UNITED STATES PATENT AND TRADEMARK OFFICE

APPLICATION NO.	FILING DATE	FIRST NAMED INVENTOR	ATTORNEY DOCKET NO.	CONFIRMATION NO.
10/607,946	06/27/2003	George A. Lopez	ICUMM.11C4C4CC1	5195

Office Action Summary	Application No. 10/607,946	Applicant(s) LOPEZ, GEORGE A.	
	Examiner THEODORE J. STIGELL	Art Unit 3763

DETAILED ACTION

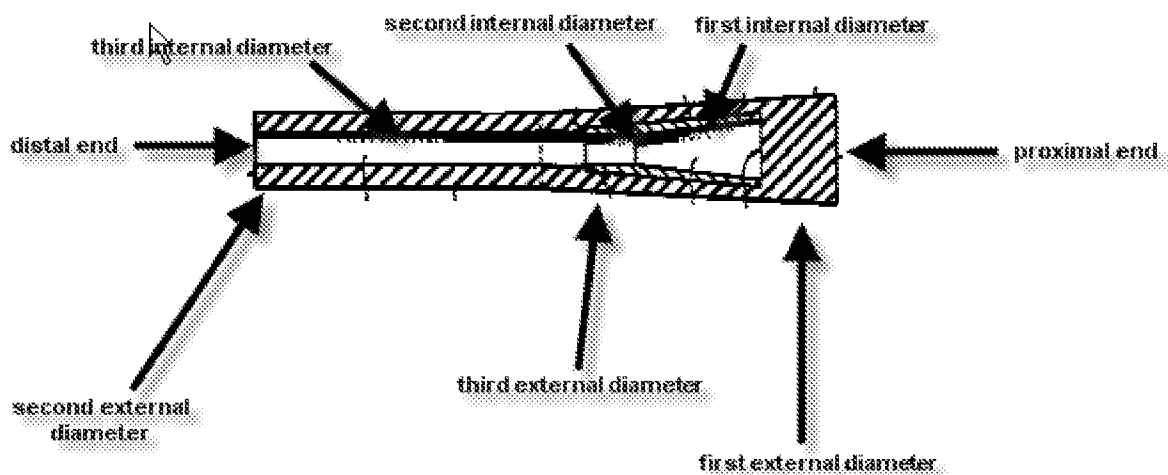
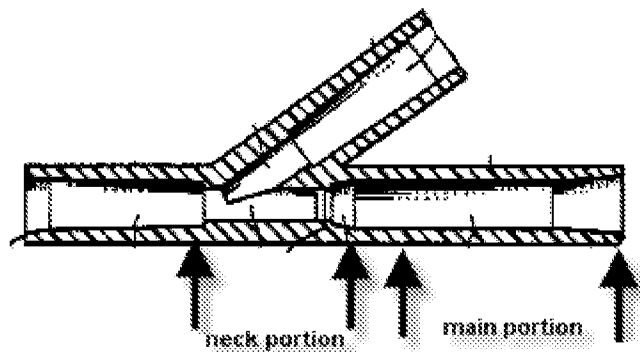
Claims 57-60, 66, and 68-69 are rejected under 35 U.S.C. 102(e) as being anticipated by Bonaldo (5,306,243). Bonaldo discloses a medical connector comprising a valve comprising an opening adapted to receive a first fluid source and a wall structure defining an internal cavity, the cavity comprising a neck portion in fluid communication with the opening and a main portion with a larger internal diameter than the neck portion, and a flexible element positioned in the cavity, the flexible element movable between a first position in which the flexible element obstructs fluid flow through the valve and a second position in which fluid flow is permitted through the valve, the flexible element comprising a proximal end, a distal end, and a flexible wall with an inner surface and an outer surface, the flexible element in the first position comprising a first external diameter near the opening, a second external diameter in the neck portion and a third external diameter in the main portion, the second external diameter being smaller than the first external diameter and the third external diameter,

and at least a portion of the outer surface of the wall of the flexible element between the first external diameter and the second external diameter being tapered, the flexible element in the first position further comprising a first internal diameter in the main portion, a second internal diameter in the main portion distal the first internal diameter, and a third internal diameter in the main portion distal the second internal diameter, the second internal diameter in the main portion being smaller than the first and third internal diameters in the main portion, a tubular main body in fluid communication with the valve, and a tubular branch adapted to receive a second fluid source and adapted to direct fluid from the second fluid source to the tubular main body. The examiner has reproduced Figures 2 and 4 for illustration.

In regards to claims 58-60, 66, and 68-69, Bonaldo further discloses a rigid, spike member (34) located within the flexible element, wherein the rigid member and the tubular branch (11) are integrally formed (product-by-process claim), wherein the rigid member assists in supporting the element, wherein the flexible element bears against the wall structure near the opening, and wherein the tubular main body (12) and the tubular branch (11) form an acute angle.
